Proposed amendment to document ECE/TRANS/WP.29/GRSP/2012/12

The text reproduced below was prepared by the secretary from the UN Global Technical Regulation (UN GTR) on safety of hydrogen fuel cell vehicle aim to reflect the result of hydrogen vehicle working group and correct to appropriate wording, i.e. editorial and clarification.

The modifications to the text of ECE/TRANS/WP.29/GRSP/2012/12 are marked in highlighted in yellow or marked as strikethrough.

Figure 7

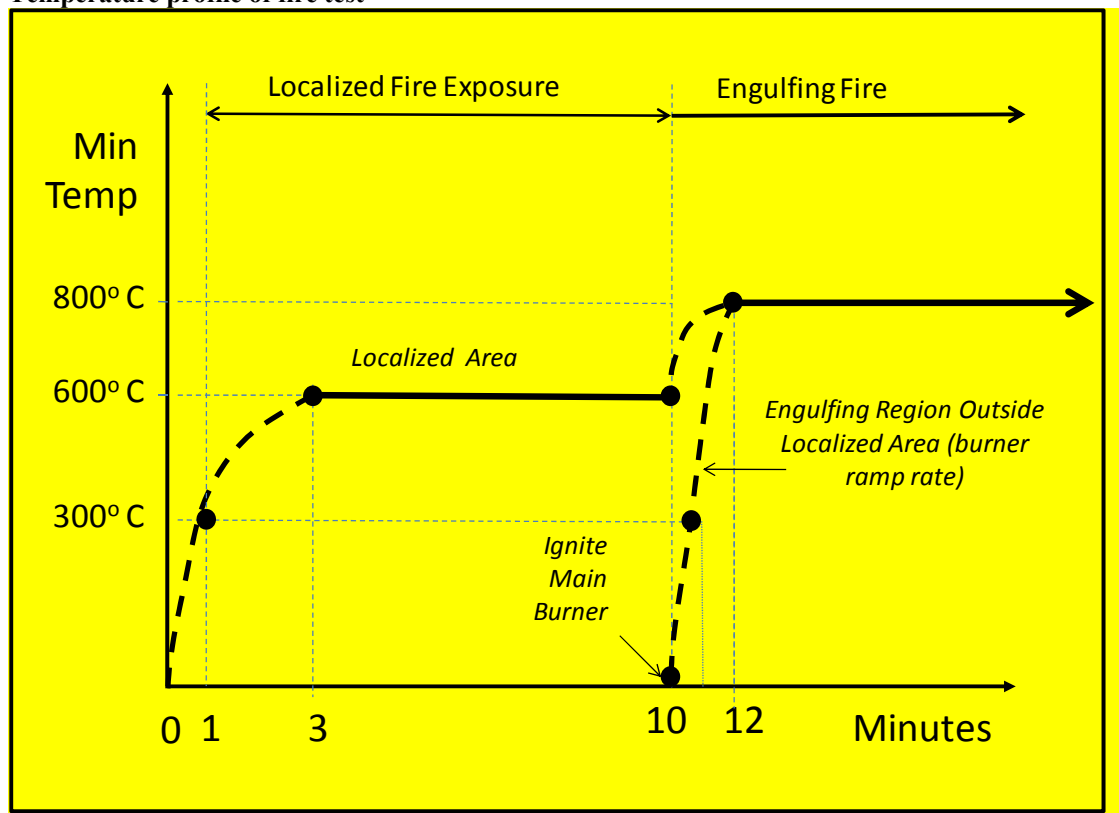
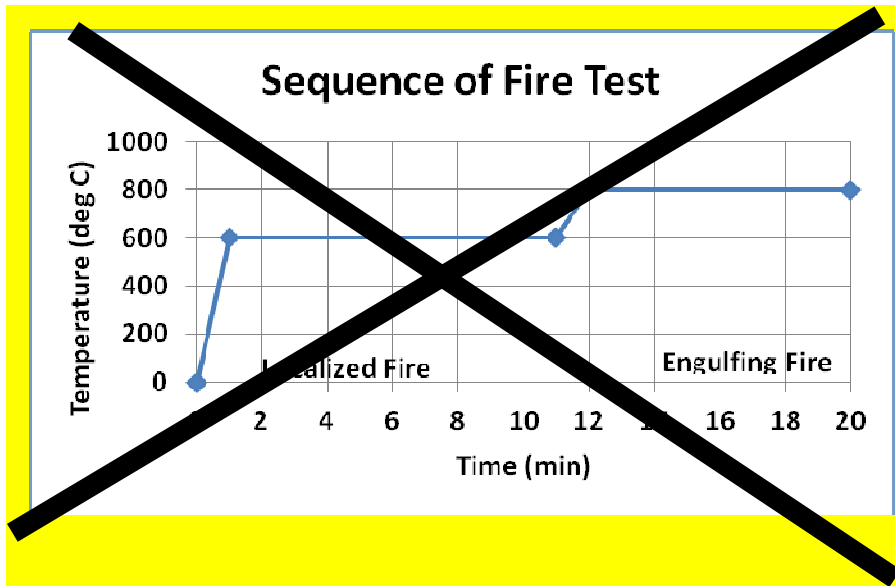
- (f) As shown in Figure 7 the temperature of the thermocouples in the localized fire area has increased continuously to at least 300 °C within 1 minute of ignition, to at least 600 °C within 3 minutes of ignition, and a temperature of at least 600 °C is maintained for the next 5-7 minutes. The temperature in the localized fire area shall not exceed 900 °C during this period. Compliance to the thermal requirements begins 1 minute after entering the period with minimum and maximum limits and is based on a 1-minute rolling average of each thermocouple in the region of interest. (Note: The temperature outside the region of the initial fire source is not specified during these initial 8 minutes from the time of ignition.)

The below profiles for fire time are being considered by SGS group:
